Remark:**(A) The display tag of Rahmey, Markman and Banks are not positioned vertically above or extends along any supporting arm of a garment hanger:**

(E) Correction of Drawings:

Appendix 1

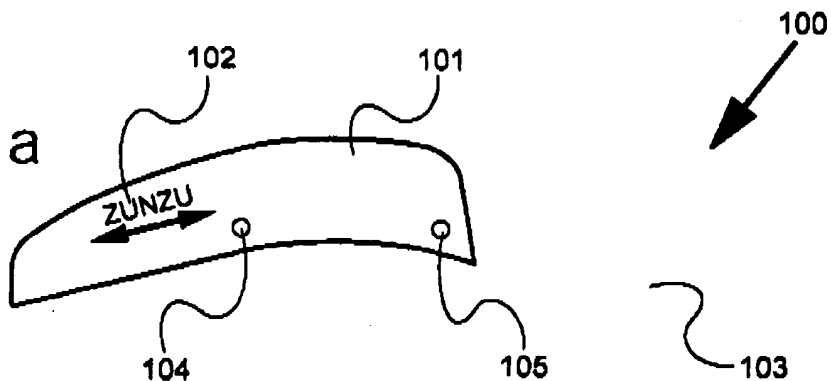
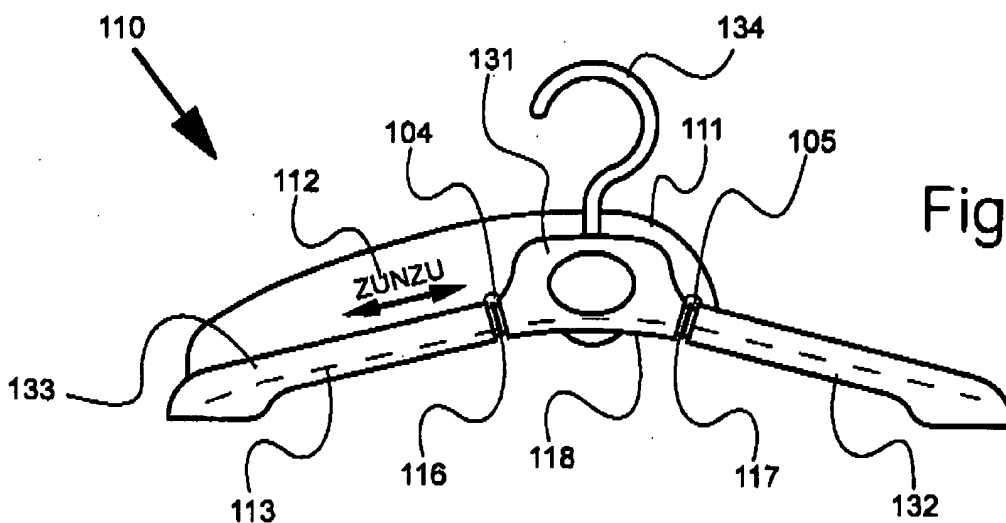
Page 3, point 7 of the office action dated -9/06/2006 objected the drawings for failing to show a hang tag extending along one of the supporting arms. Corrected drawing was requested by the office action. Please refer to the discussion in (F)

- (F) **28-35 is rejected under 35 U.S.C. 112 for the drawings being failed to demonstrate how a hang tag positioned vertically above one of the supporting arm can be achieved.**

(1) The applicant respectfully “unofficially” submit the reference sketch as shown in appendix A of this response showing how a display area positioned vertically above a supporting arm according to the common sense of a person having ordinary skill in the art according to the teaching of the disclosure of the subject invention – simply remove the display area vertically on top of the second arm.

(3) In order to further cooperate with the professional view point of the examiner, independent claims 28 and 31 are now further amended for the display area to position vertically above/extending along "at least one" of said supporting arms. There is subtle difference between the amended claim and the original claim. The existing specification satisfies the requirement of the amended claim language but not the original claim. Technically the amended claims now satisfy the disclosure requirements of the patent law – to show a preferred embodiment that satisfies the "at least one" characteristic.

The examiner is requested to inform the applicant if claims 28 and 31 are acceptable as amended to overcome the rejection of 35 U.S.C. 112 (and also the drawing objection) or if the sketch shown in Appendix A is not treated as a new matter that can be submitted to overcome the objection of drawings and overcoming the rejection 35 U.S.C. 112 at the same time. Although the examiner is also respectfully solicited to allow the subject claims as amended, the examiner is invited to propose further amendment pursuant to MPEP 707.07(j) for the subject claim to overcome the 35 U.S.C. 112 rejection, without narrowing the scope of the subject claim.
